**MONTGOMERY COUNTY
PLANNING COMMISSION**

September 12, 2012

Re: MCPC #12-0076-003
Amend Zoning Ordinance: Regulating
Motor Vehicle Fueling Center, Signs
Abington Township

Wawa with HVAC screened from road, limited curb cuts, and defined entrance driveways, East Norriton, below

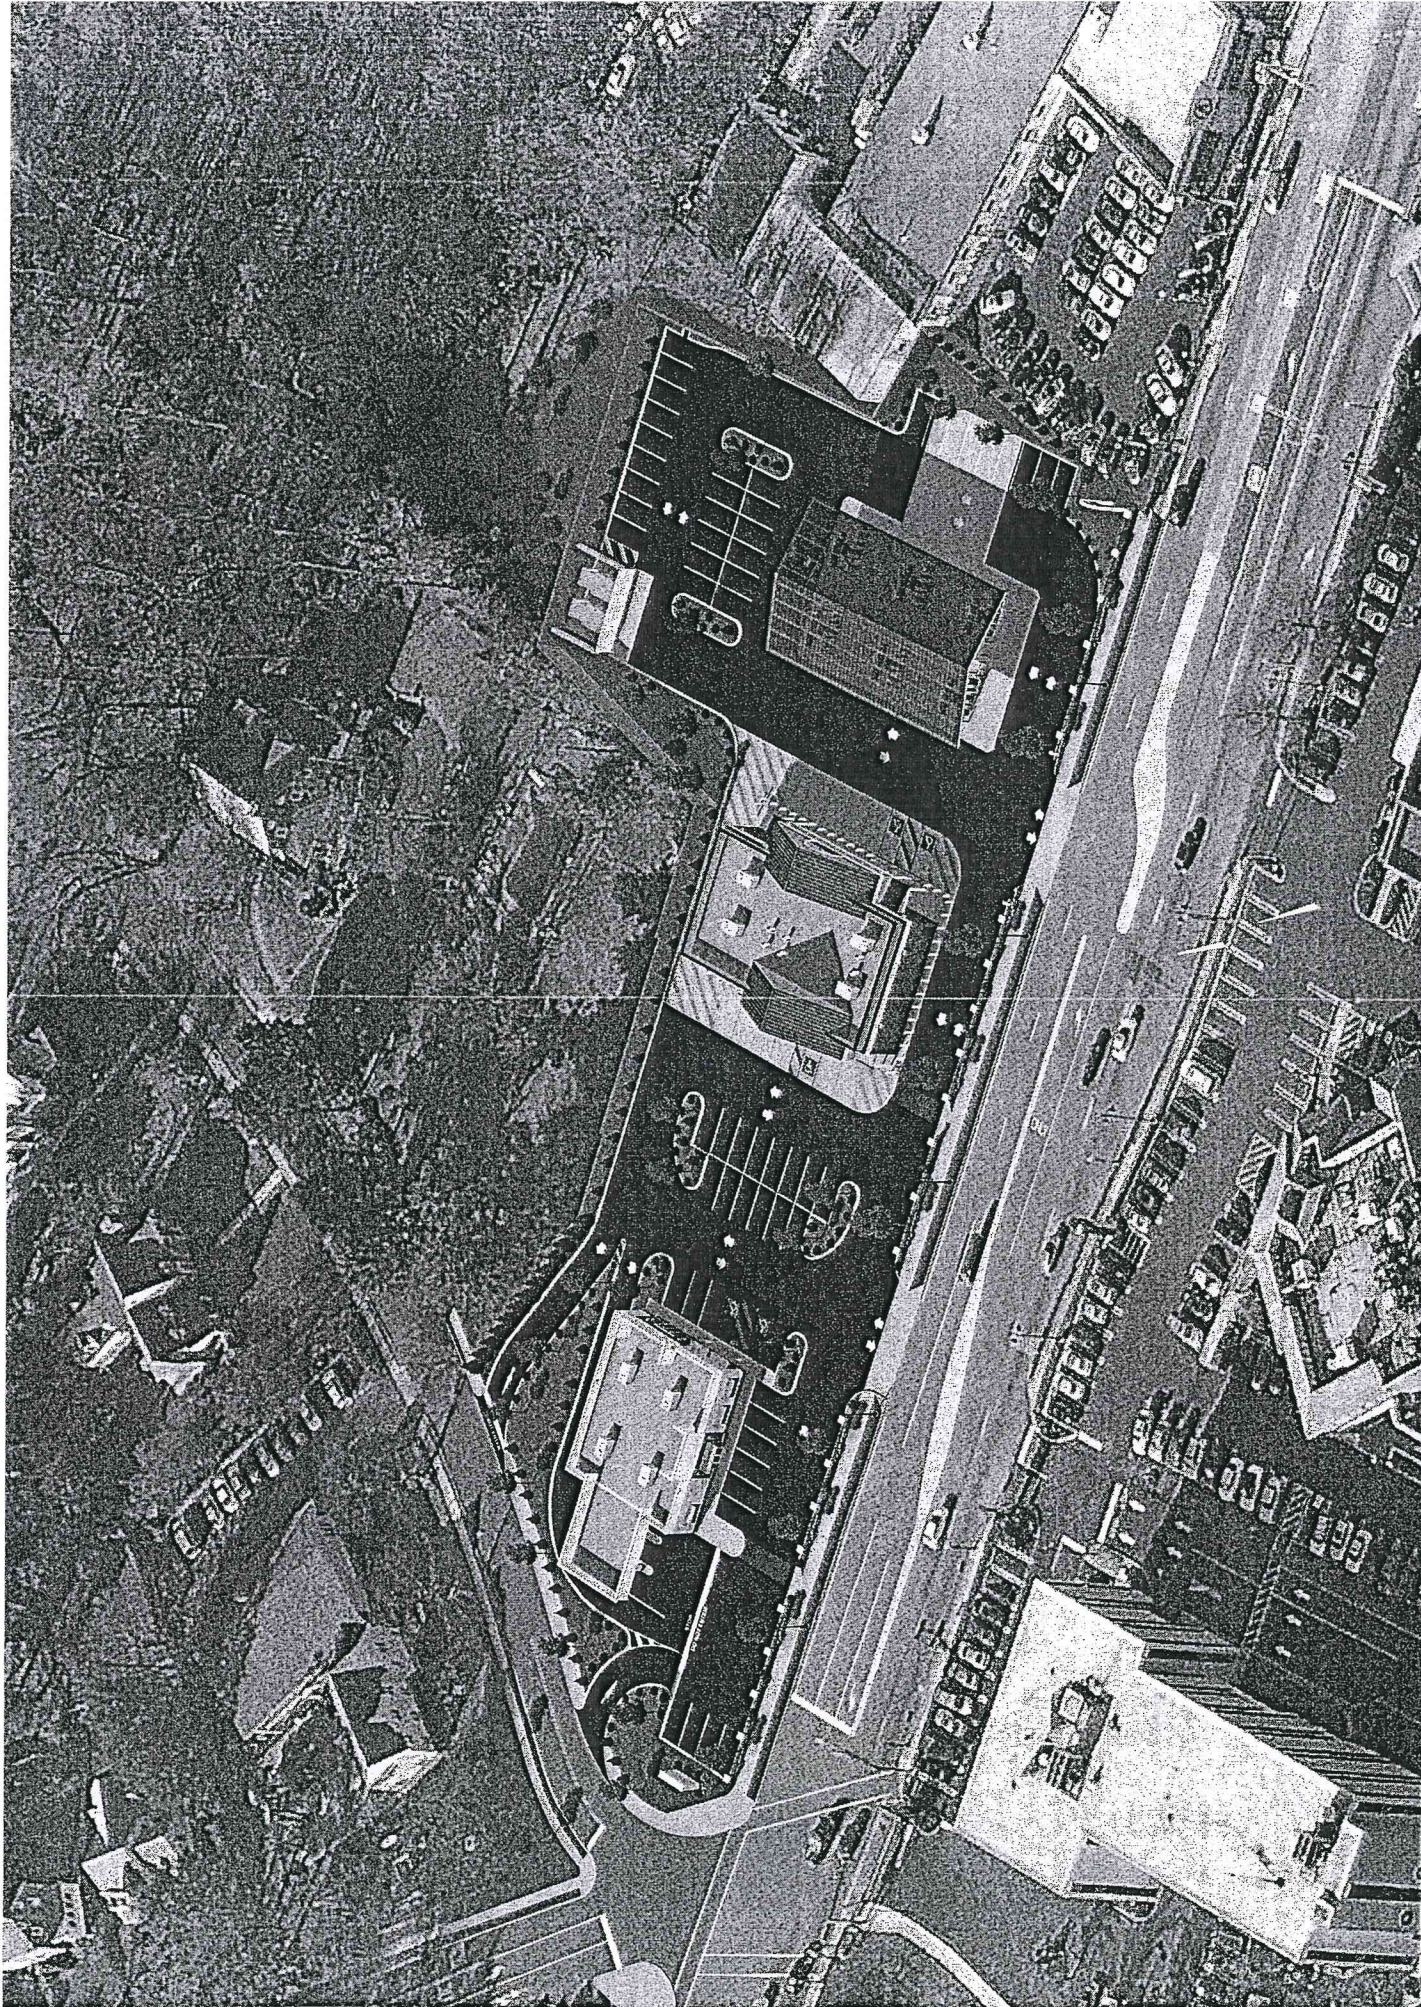
8. HVAC equipment should be required to be screened from view from the street and adjacent properties. Many Wawa's use the roof line or decorative parapet walls to screen HVAC equipment (see photo, attached).

CONCEPT IMAGE

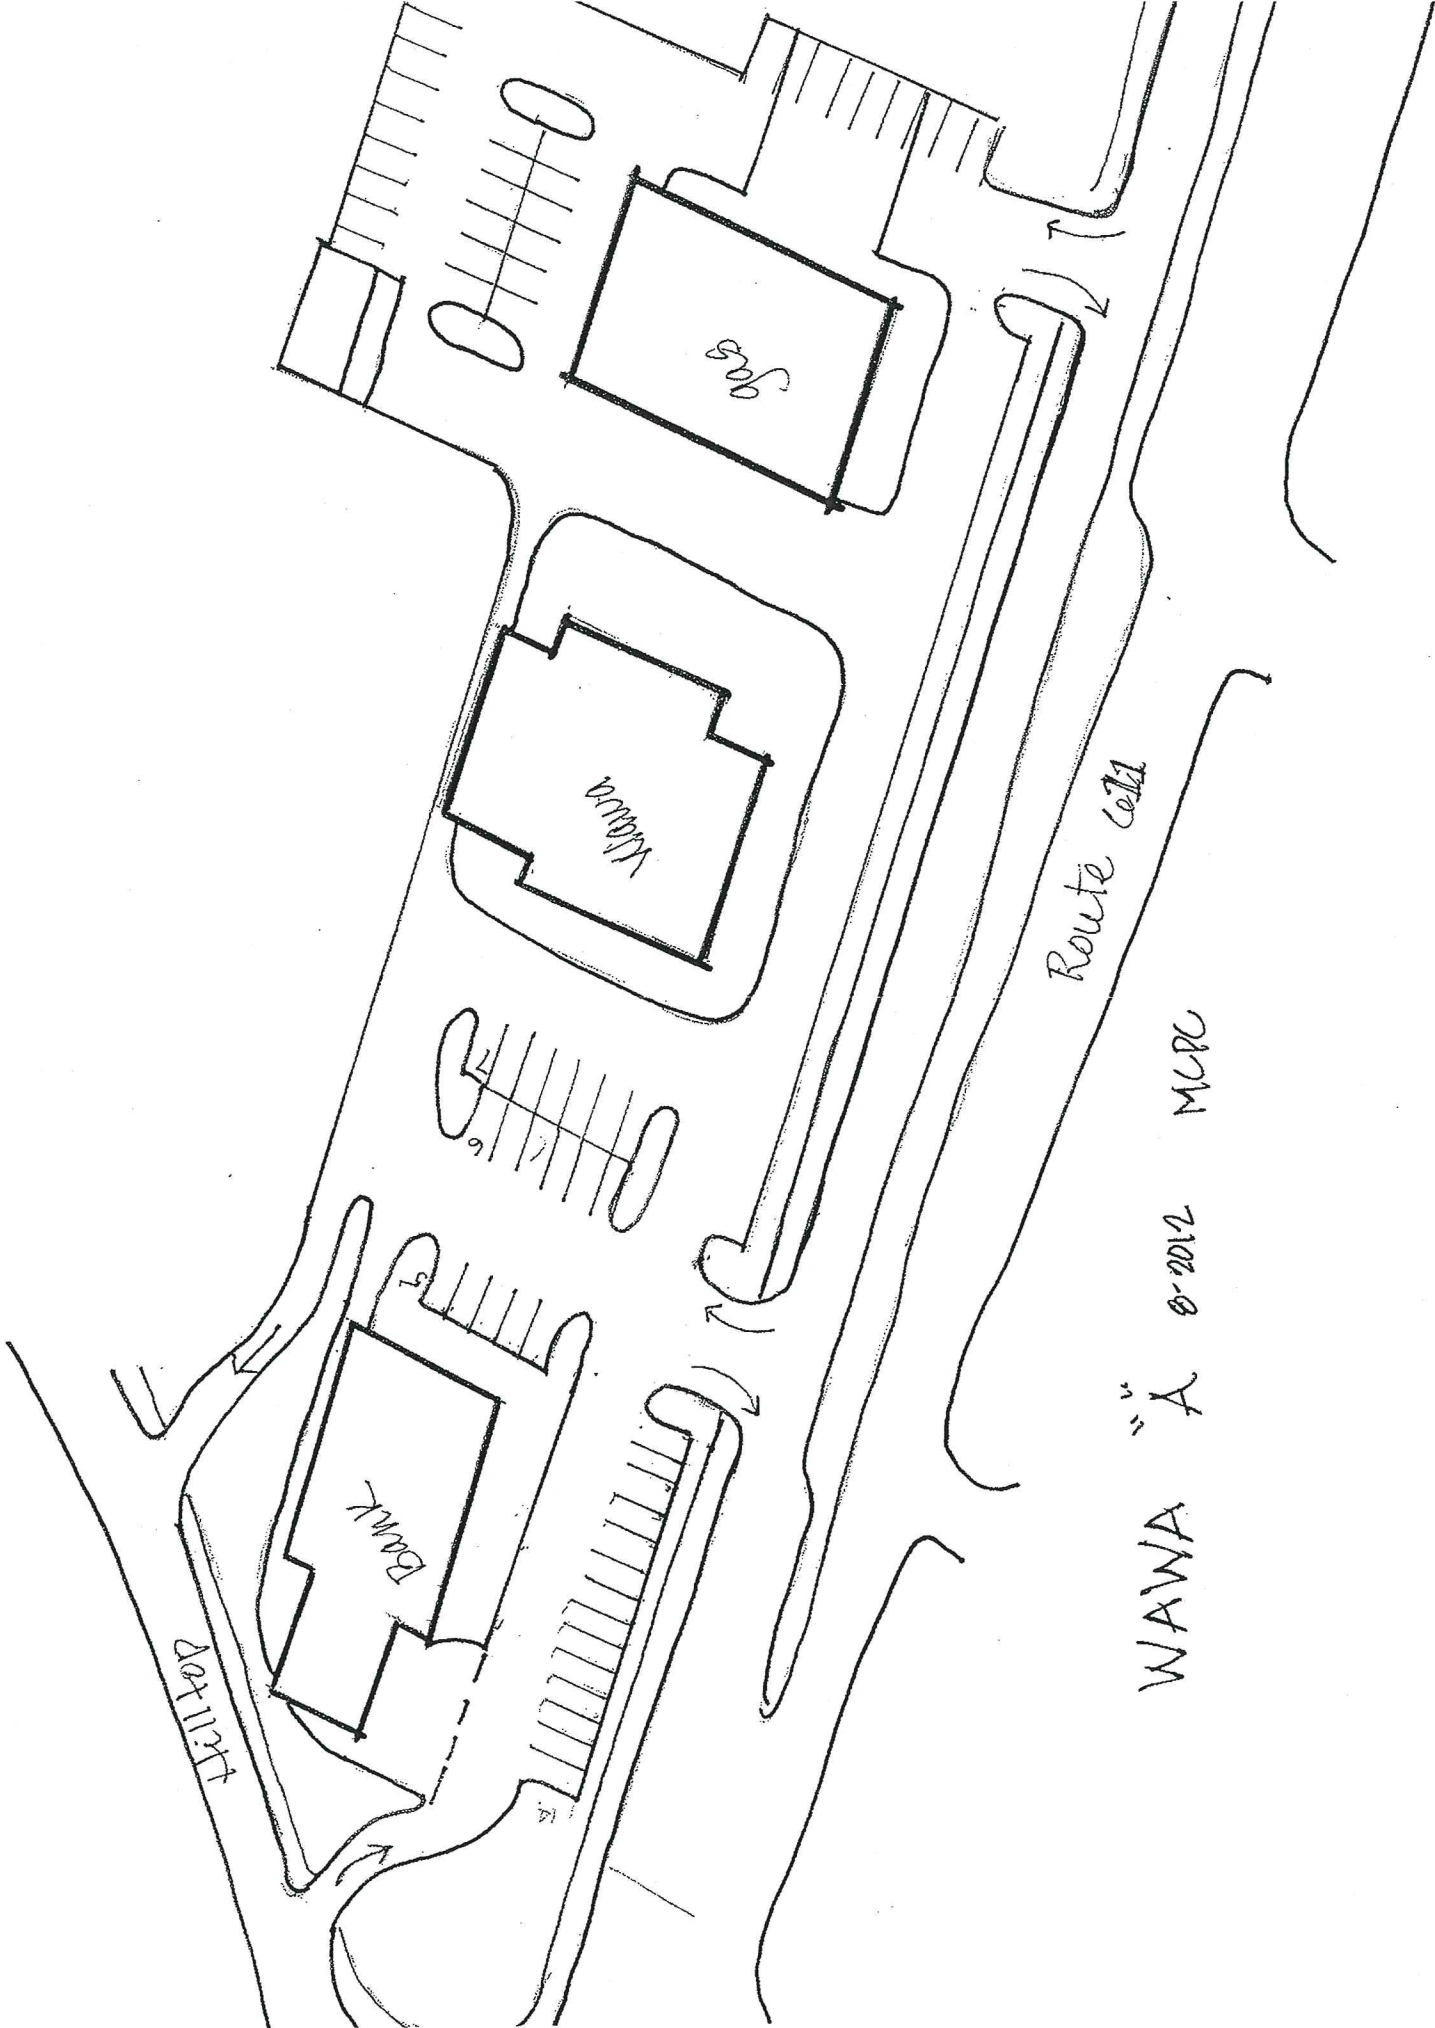
- a. *Maximum Number of Vehicular Access Points.* We recommend the maximum number of vehicular access points be capped at two, rather than three shown in the Concept Images (see attached photo and Hilltop Road entrance on conceptual site redesign "B").
- b. *Distance Between Vehicular Access Points.* We recommend that access points on the same street frontage be separated by a minimum distance of 300 feet, consistent with the County's model General Commercial District (available at www.planning.montcopa.org, by following the "Publications" link). Looking at the Concept Images accompanying the proposed zoning amendment, we suggest that the plan's vehicular circulation might be improved by relocating the northernmost vehicular access point on Old York Road close to the northern tract boundary. This would improve vehicular circulation within the site (see attached conceptual site redesign).

3. Median Cut. The Concept Images attached to the proposed ordinance show a median cut allowing left-turns from northbound Old York Road into the site. Apparently PennDOT supports this concept, so we defer to them.

- a. All entry driveways should be required to have sidewalks (including Hilltop Road in the Concept Image).
- b. Sidewalks along Old York Road should be required to have a minimum width of 8 feet, with a minimum verge area of 5 feet, and minimum green area separating the sidewalk from the parking lot of 8 feet (this concept is shown on the Concept Image). This is consistent with

5. Parking. Is there enough parking for the Wawa shown on the Concept Images?

10. Parking Lot Landscaping. On the Concept Image, the corner of the Wawa show a hatched, yellow marking, at the end of parking rows fronting the store entrances. We recommend that motor vehicle fueling centers require such areas to be green landscaped areas.

2. The location shown on the Concept Images would be a suitable place for a Gateway Sign facing south, welcoming people to Abington Township. The Old York Road Plan recommends such a sign be constructed at the corner of Old York Road and Hilltop Road.
3. We recommend that at least one freestanding sign advertise all businesses on-site.

WAWA "B" 0-2012 MCR

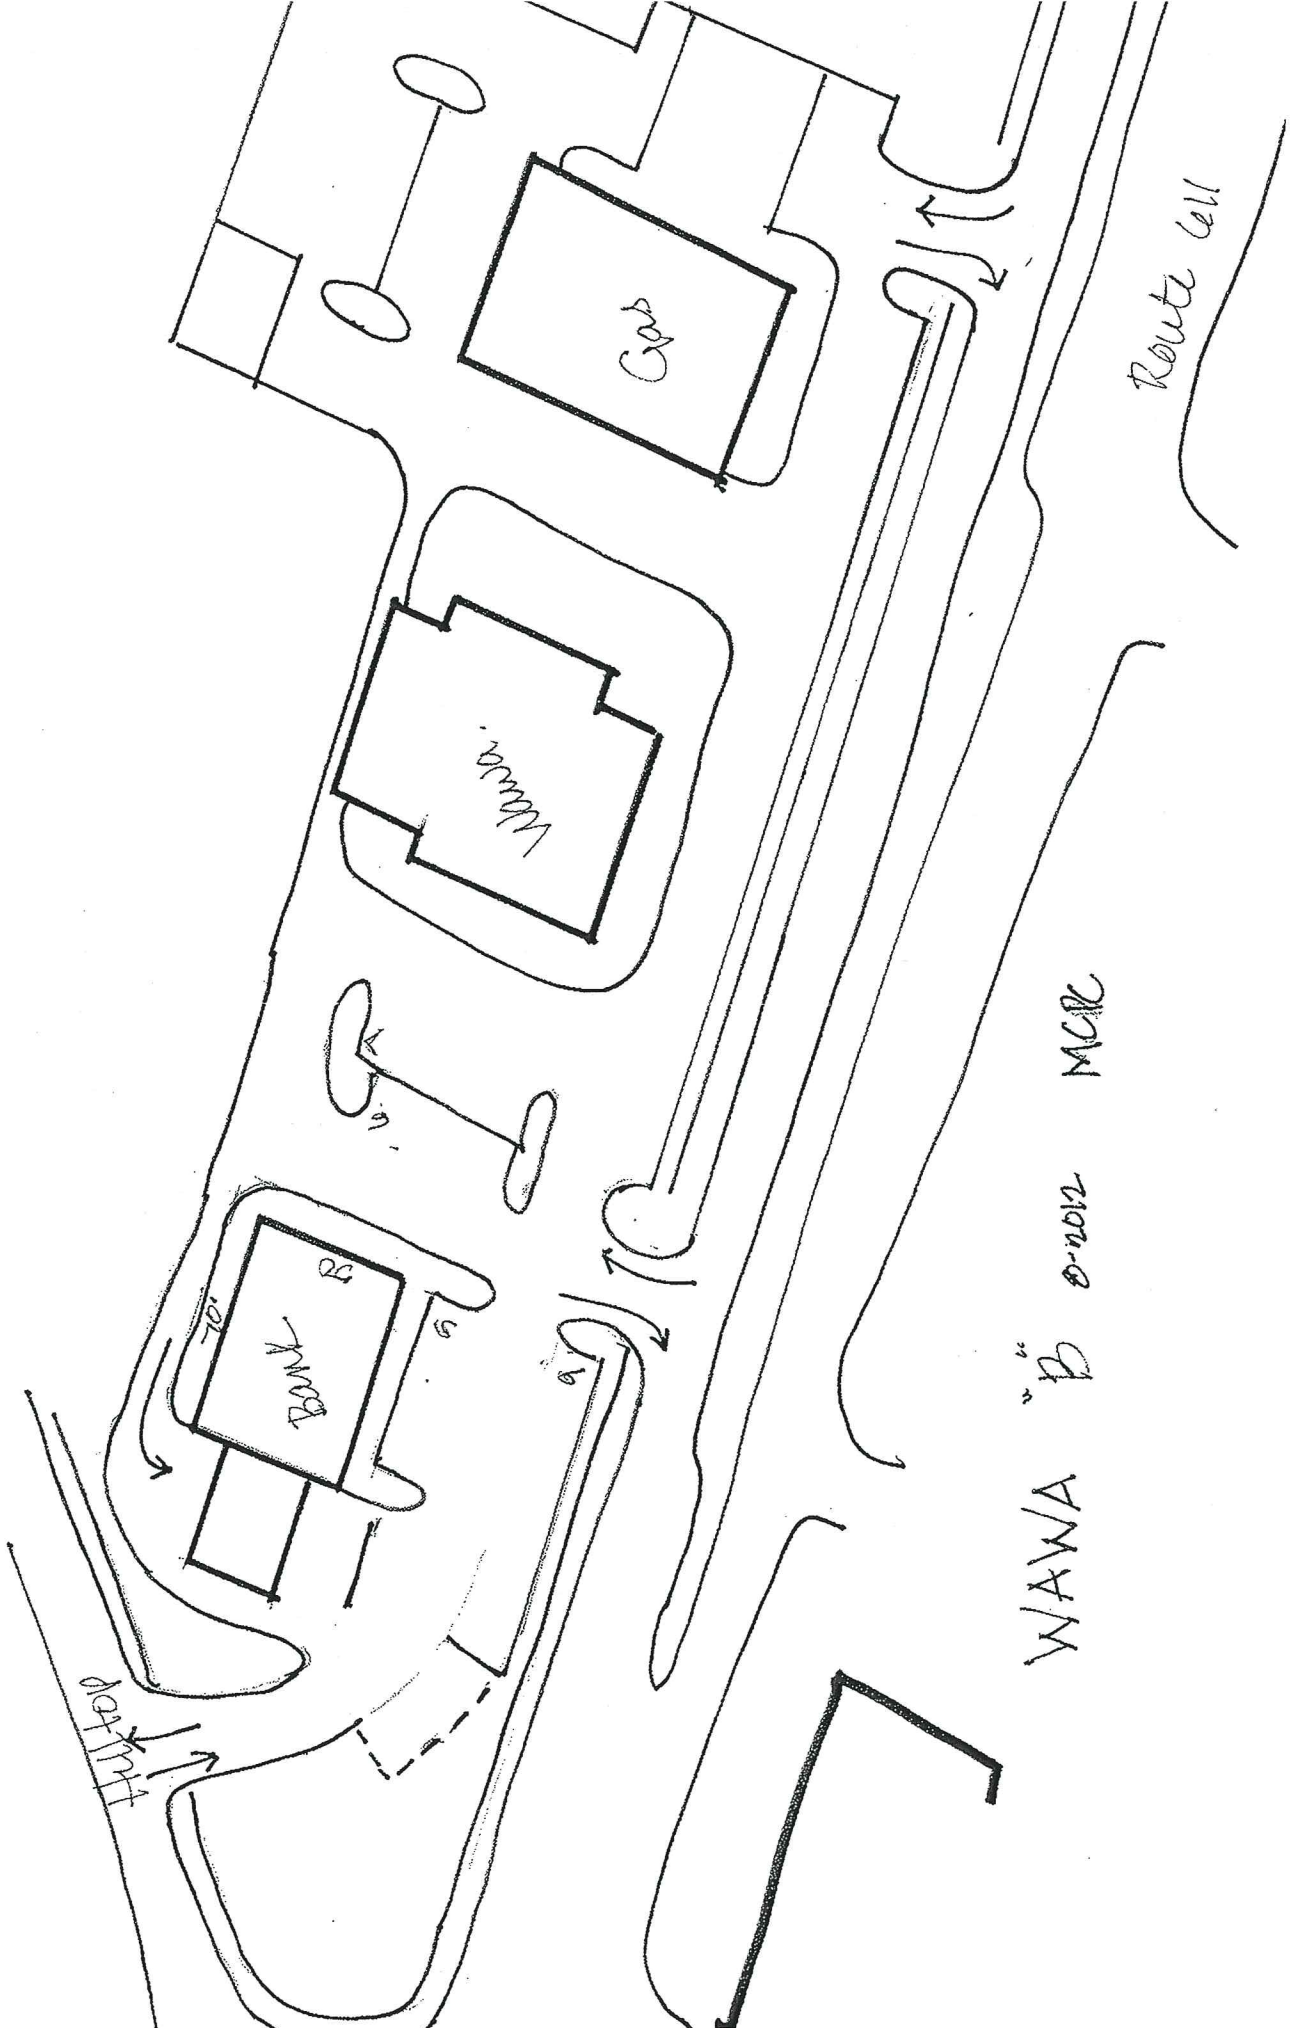
A. Vehicular and Pedestrian Access. The following recommendations would help promote a pedestrian-friendly environment along Old York Road. MCPC prepared two conceptual site redesign sketches of the site for which Concept Images were prepared by 3GHC Architects. These, particularly sketch "B", which limits access points on Hilltop Road, show how access and circulation might be improved (see attached).
